APPLICABILITY: 2014MY Crosstrek Hybrid (HEV) **NUMBER:** 07-132-18
SUBJECT: DTC P1C14- Revised Diagnostic Procedures **DATE:** 01/26/18

This bulletin provides a revised diagnostic procedure for DTC P1C14 (Generator Performance).

WIRING DIAGRAM:

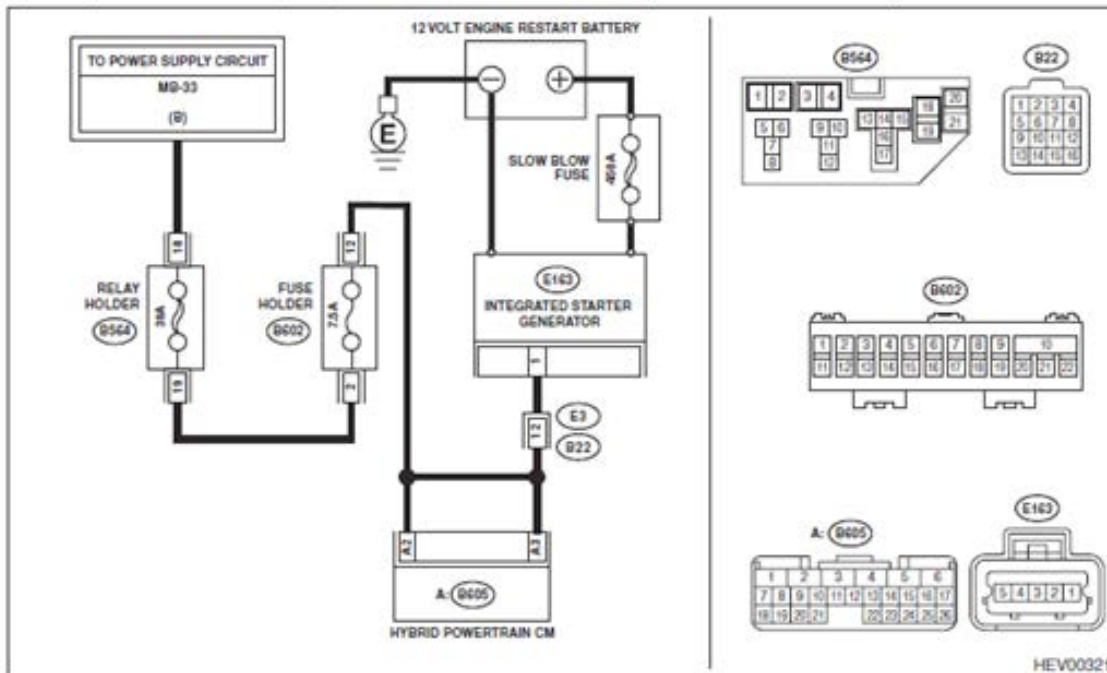
The previous diagnostic procedure stated to replace the Integrated Starter Generator (ISG) if P1C14 was found stored in memory. The corrected procedure provides additional diagnostic steps to help prevent unnecessary ISG replacements. Screen shots of the revised diagnostic steps are provided below.

Step	Check	Yes	No	
1	CHECK DTC. Read the DTC. <Ref. to HEV(diag)-24, HYBRID POWERTRAIN CONTROL SYSTEM, OPERATION, Read Diagnostic Trouble Code (DTC).>	Are any other DTCs (relating to ISG) detected? (current malfunction)	First diagnose other DTCs.	Go to step 2.
2	CHECK FUSE. Check the fuse. <Ref. to HEV-12, Relay and Fuse.>	Is there any fault?	Replace the fuse. If the fuse blows out easily, repair the short circuit of harness.	Go to step 3.
3	CHECK BATTERY CABLE ASSEMBLY. Check the battery cable assembly. <Ref. to SC(H4DO(HEV))-50, Battery Cable Assembly.>	Is there any fault?	Repair the battery cable assembly.	Go to step 4.
4	CHECK BATTERY. Check the 12 volt engine restart battery. <Ref. to SC(H4DO(HEV))-39, Battery.>	Is there any fault?	Charge or replace the 12 volt engine restart battery.	Go to step 5.

Step	Check	Yes	No	
5	CHECK DTC. Read the DTC. <Ref. to HEV(diag)-24, HYBRID POWERTRAIN CONTROL SYSTEM, OPERATION, Read Diagnostic Trouble Code (DTC).>	Is DTC P1C14 detected? (current malfunction)	Replace the integrated starter generator. <Ref. to SC(H4DO(HEV))-32, Integrated Starter Generator (ISG).>	Even if DTC is detected, the circuit has returned to a normal condition at this time. Reproduce the failure, and then perform the diagnosis again. NOTE: In this case, temporary poor contact of connector, temporary open or short circuit of harness may be the cause.
